CITY OF ALBUQUERQUE

February 27, 2019

RE: **Matthew Townhomes**
2145 Matthew NW
Grading and Drainage Plan
Engineer's Stamp Date: 2/5/19
Hydrology File: G12D036

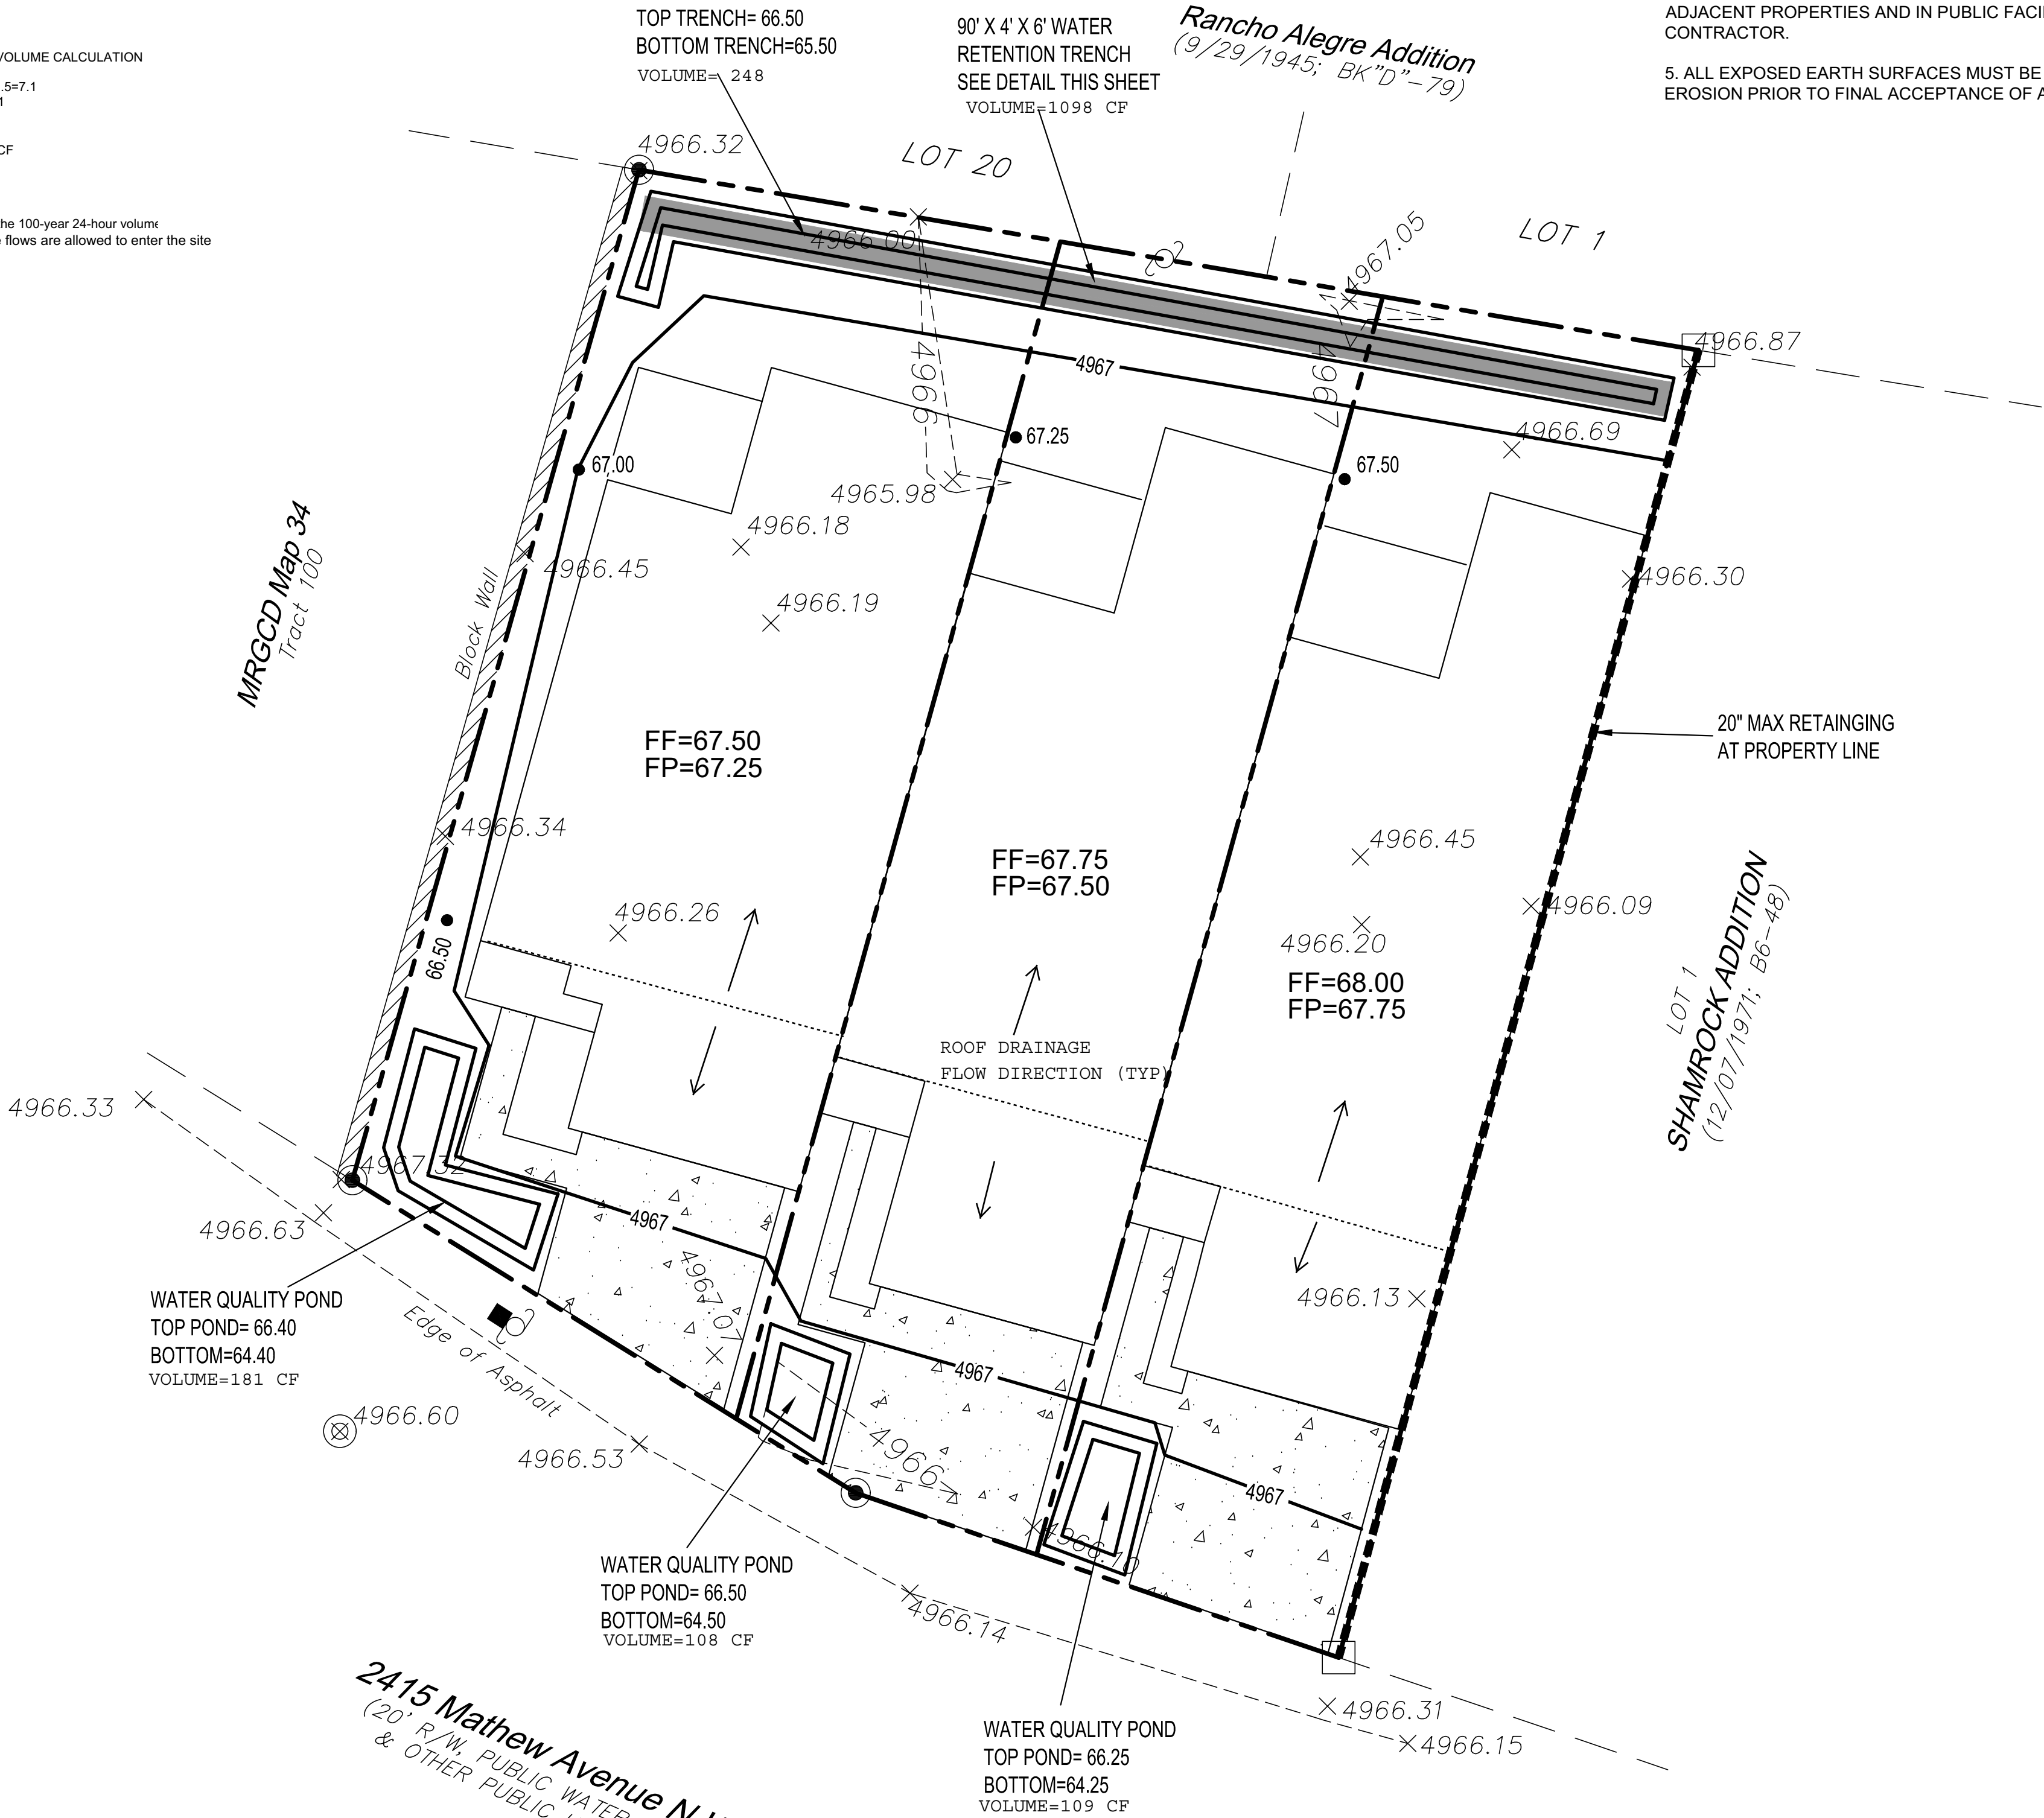
Based on the submittal received on 2/6/19, the Grading and Drainage Plan is approved for Final Plat and Building Permit. On the Plat, provide a drainage easement over the pond and annotate using the [Plat Drainage Easement Note](#). This note replaces the need for a separate drainage covenant.

1. Engineer's Certification, per the DPM Chapter 22.7: *Engineer's Certification Checklist For Non-Subdivision* is required.
2. The Plat will need to be recorded and a copy included with the Engineer's Certification.
